From: Gedney, David
Sent: 07 September 2015 16:50
To: _planningadvice
Subject: FW: Planning Application H23-0649-15 - Barn conversion to residential studio, Adj 42 Broadgate, Whaplode Drove - Mr J Burchnall
Attachments: 2796-15-02A(BURCHNALL).pdf

A		END ELEVATION WINDOW MEASUREMENTS - PLANNING	SEPT 2015
GRM	revision		date
G. R. MERCHANT LTD. I. ENG AMICE FIWO ARCHITECTURAL, STRUCTURAL AND LAND DRAINAGE CONSULTANTS 4 Wrights Mews 12A Park Road, Holbeach, Spalding, Lincs. PE12 7EE Tel: 01406 490800 Fax: 01406 42744 E-Mail: gr.merchant@btconnect.com			
Project BARN CONVERSION TO RESIDENTIAL STUDIO. Adj: 42 BROADGATE, WHAPLODE DRIVE, SPALDING, LINC'S.			
Client JONATHAN BURCHNALL (FENNITE)

Drawing FLOOR PLANS & ELEVATIONS, SITE & LOCATION PLANS.			
Job Ref.	Drawing No.		
2796-15.	02A.		
Date	Drawn		
JUNE 2015.	GRM.		
Scales 1/ 50. 1/ 100. (unless otherwise stated)			
DO NOT SCALE FROM THIS DRAWING This drawing is copyright and may not be altered, traced, photographed or used for any other purpose other than that for which it is issued. The General Contractor is to check all dimensions on site and report any discrepancies to the Architect. At details shown on this drawing including fo

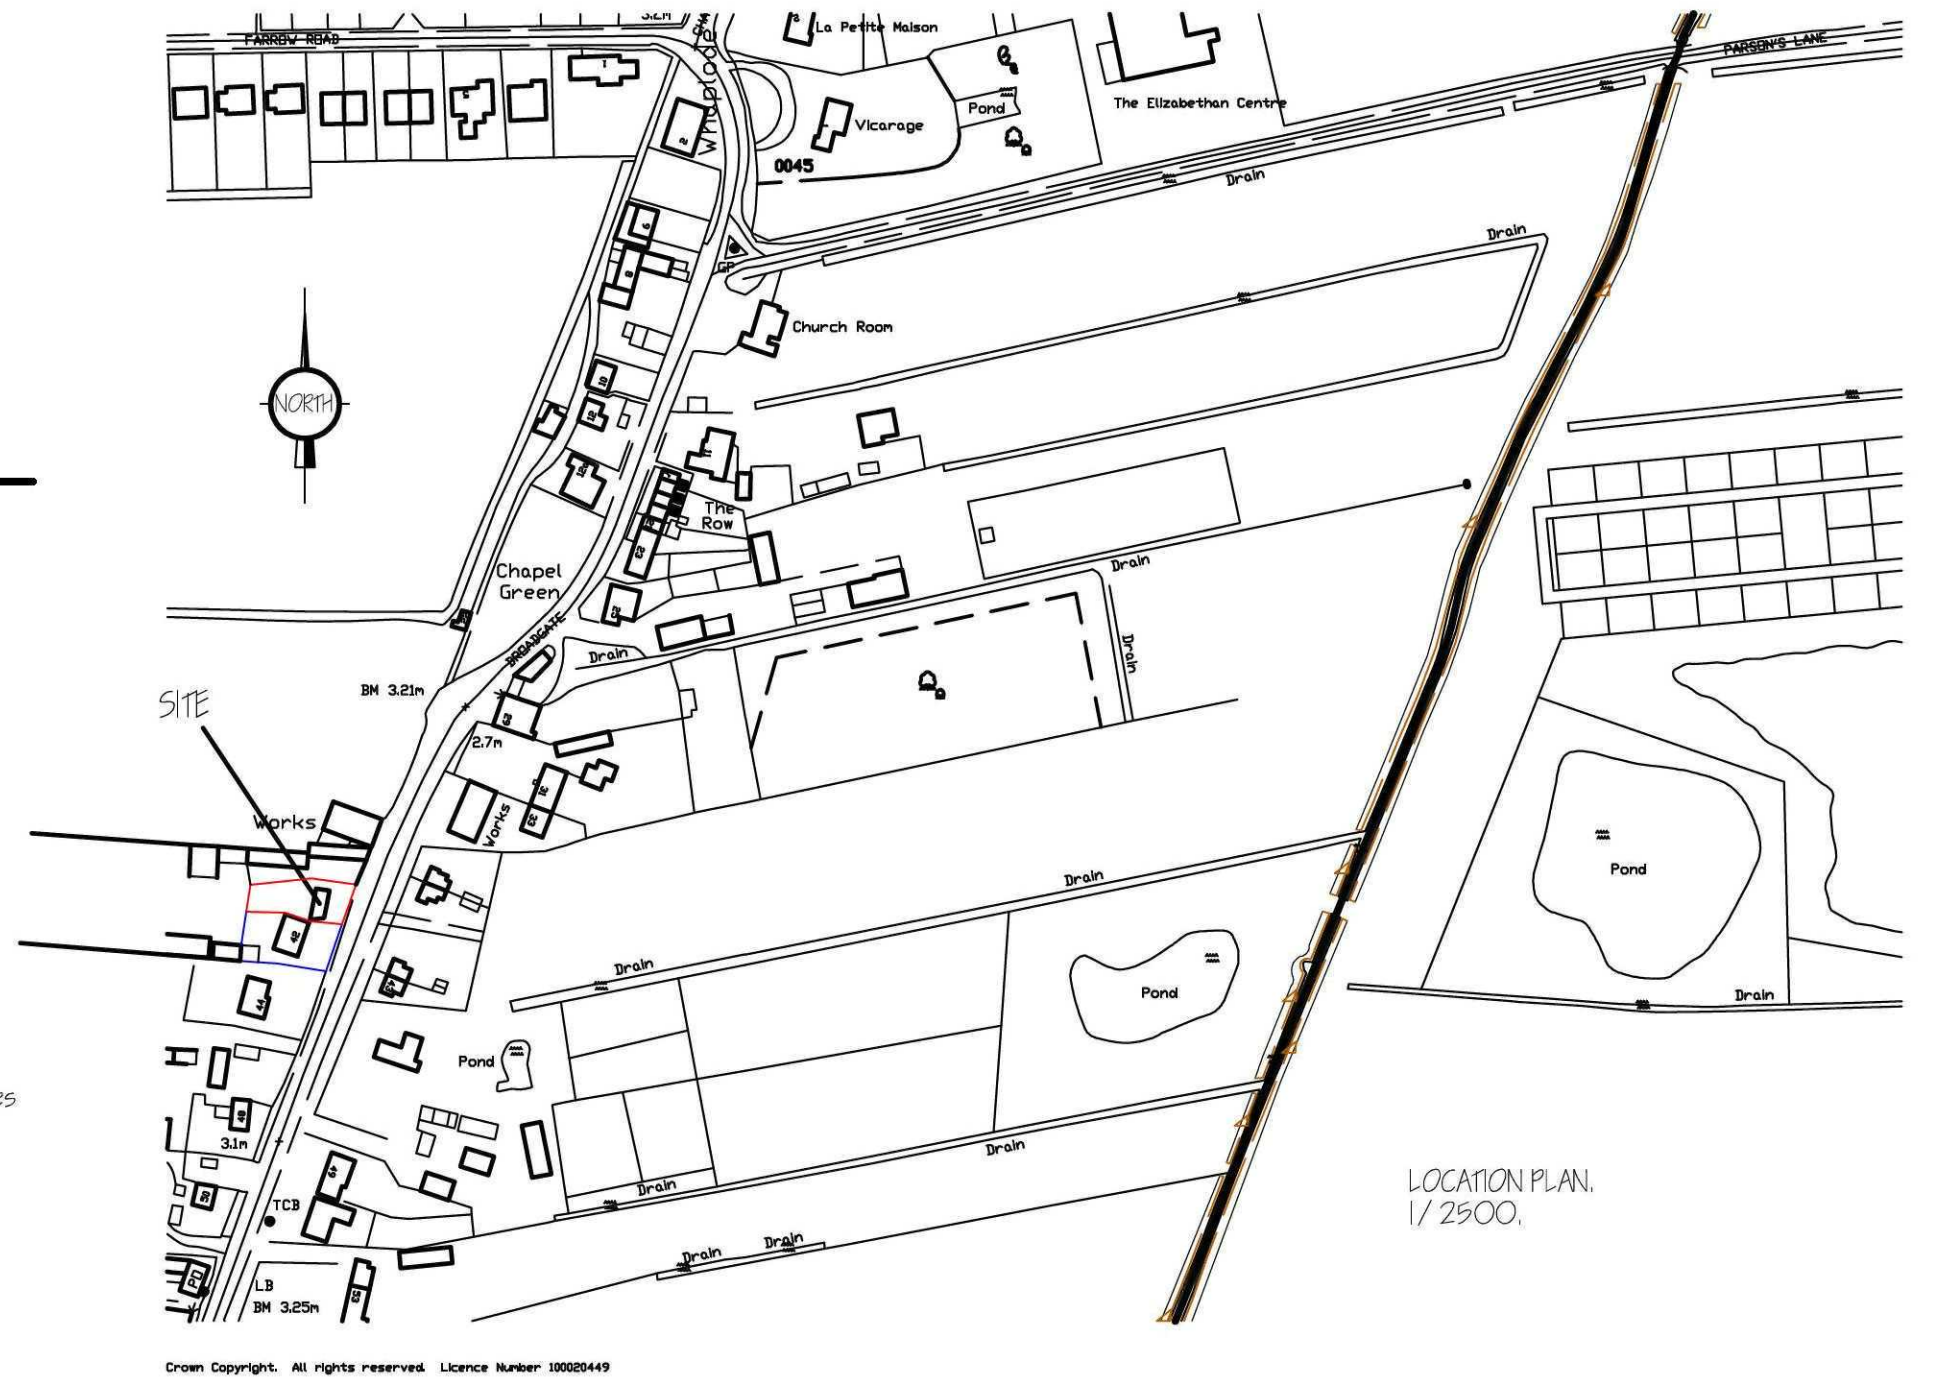
For clarification, the proposed kitchen window on the southern elevation appears to be higher than the existing opening. It is assumed that it is going to be re-positioned to avoid overlooking of the neighbouring residential property and to utilise an existing lintol at the higher level. Please confirm that this is the case.

Brick-up existing window & re-position new window at higher level to avoid over-looking into neighbouring property (No-42) - RE-USE EXISTING LINTEL.
